**SUNDRY NOTICE**

**Conditions of Approval – January 4, 2012**

**Grand Valley Pit # 1; Facility ID: 426954**

**Subject: Engineering Consultation- Existing Pits**  
**Grand Valley Pit #1, #2 and #3**  
**Garfield County, Colorado**  
**Terracon Job No. AD125007**

POND #1 (AS-BUILT DRAWING)

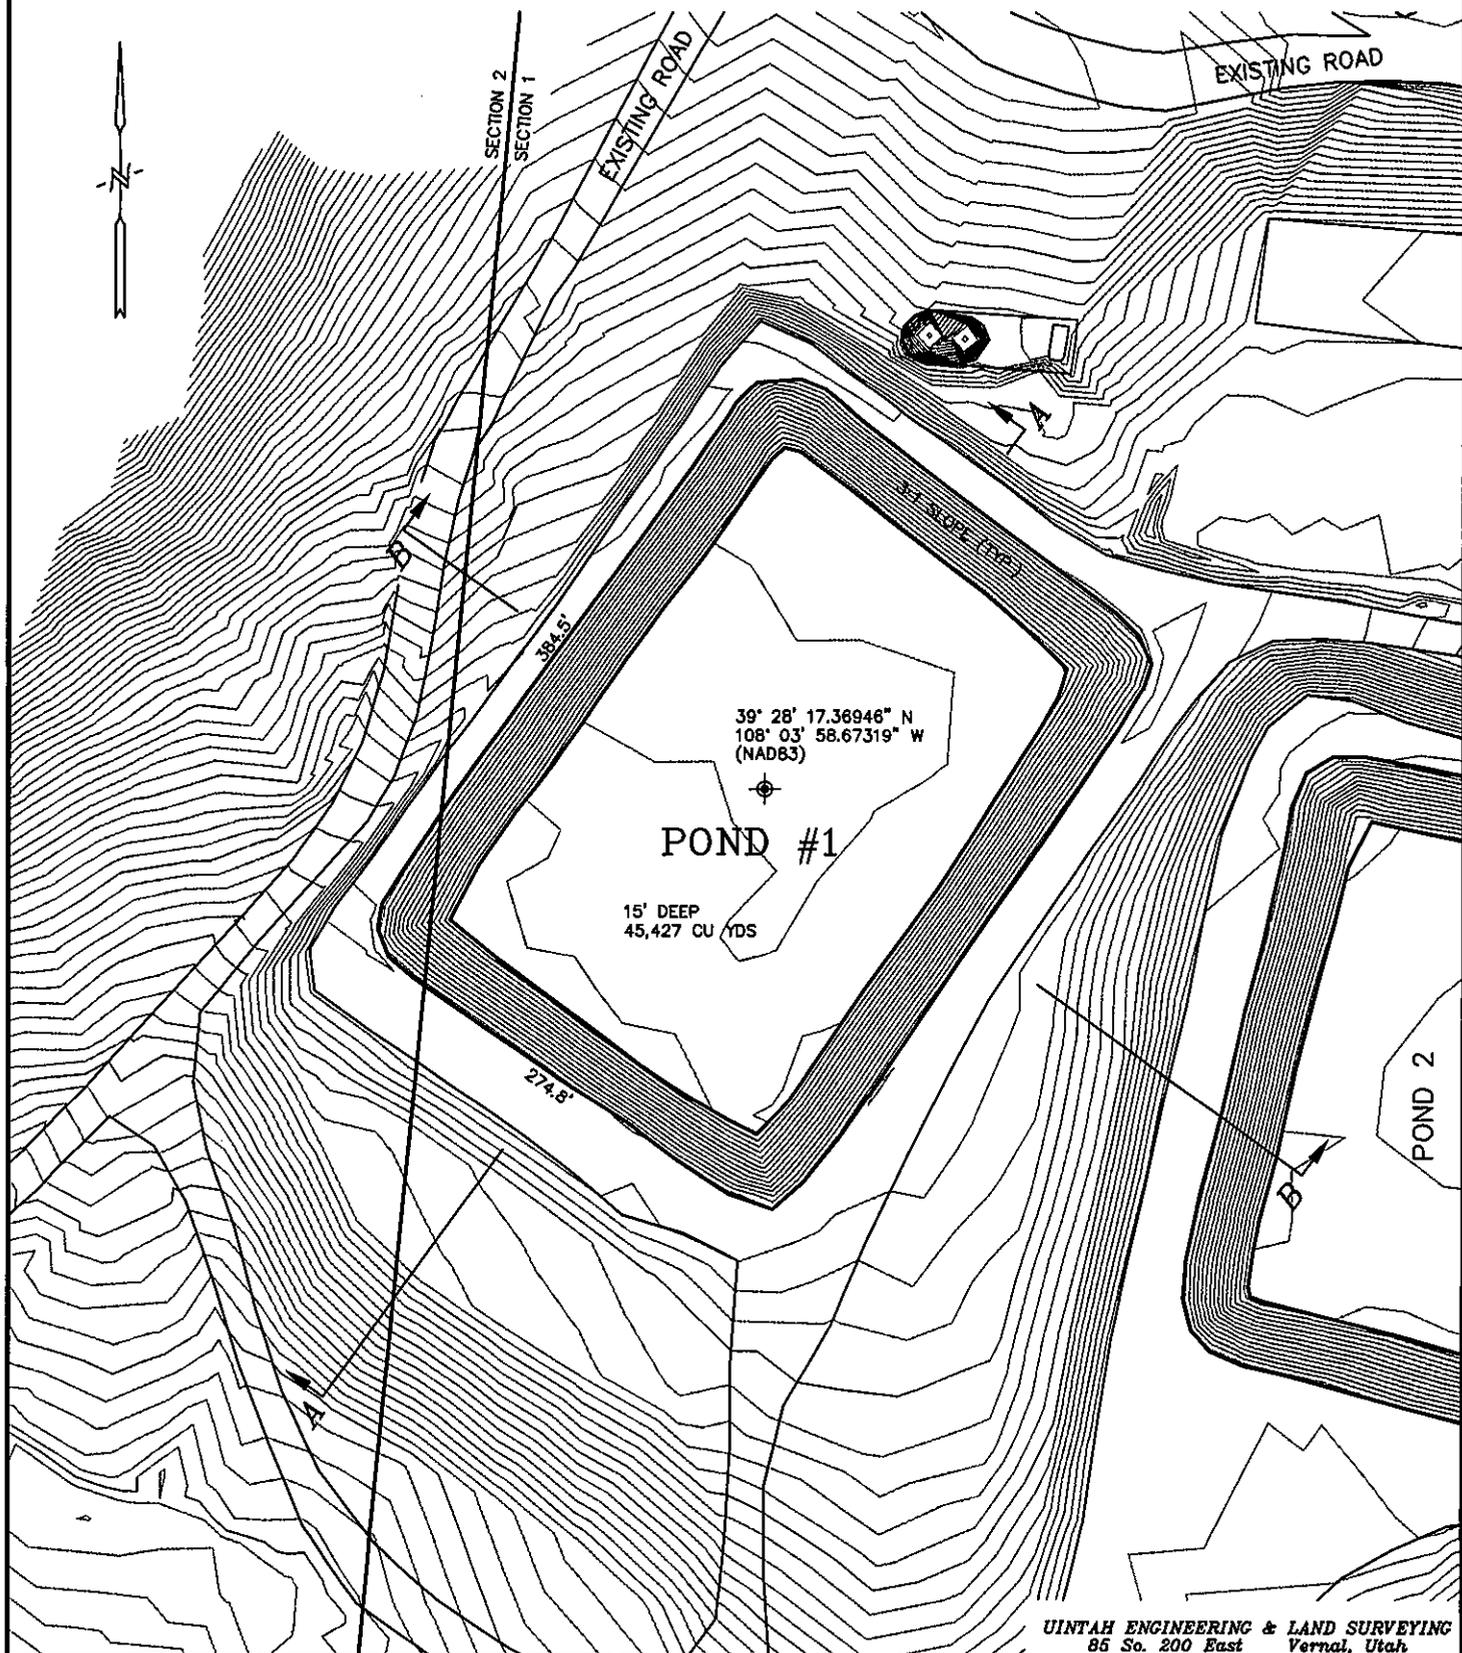
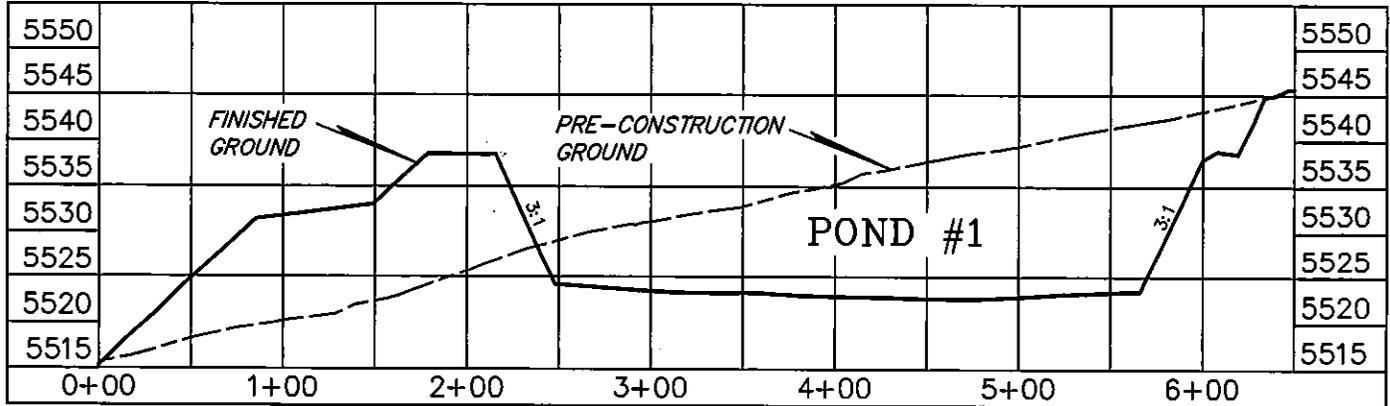
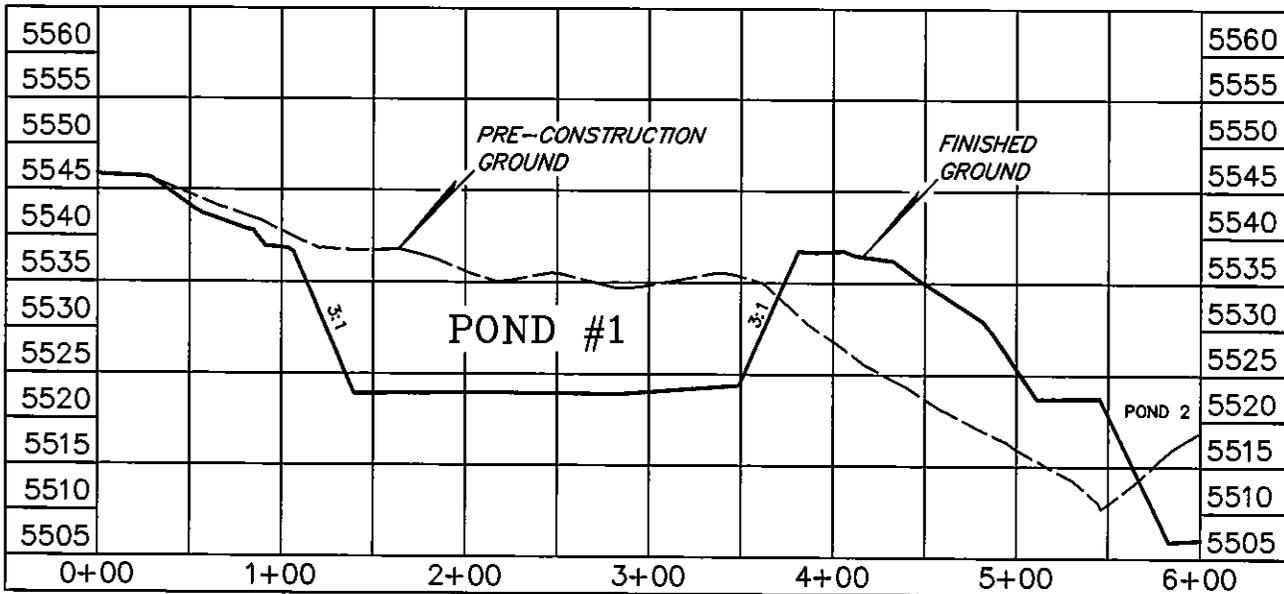
Pit is constructed in fill. Provide a Professional Engineer (P.E.) stamped review of the as-built construction of the pit and integrity of the pit.

Provide the as-built construction details.

Site embankment fills such as in the southwest end of the pits and the dividing areas between pits were not tested. Construction documents (reference Uintah Engineering and Land Surveying, AS-BUILT drawings dated October 28, 2010 for each pit, attached) show existing embankment fill depths varying up to 5 to 10 feet at each of the pits. In our opinion, the amount of time since construction of 2 ½ years with no apparent damages and the level of 24 hour operational monitoring at this site indicate it is very unlikely that any one time event could damage the existing fill to cause a release. However, we do not recommend construction on the embankments unless foundation engineering considers the existence of man made fill. We also believe that a reoccurring yearly reobservation is warranted. We recommend the observations be performed by a Colorado registered P.E. to check for evidence of ongoing fill consolidation or liner tension, considering the lack of construction documentation of fills at the subject site.

1. P.E. stamped review of the as-built construction of the pit and integrity of the pit considering existing fill

The information and limitations contained in this report serves as our review of the as-built construction. Considering existing fill, we believe a reoccurring yearly reobservation made by a Colorado licensed P.E., as described above to check for evidence of fill consolidation, is warranted. The next item,
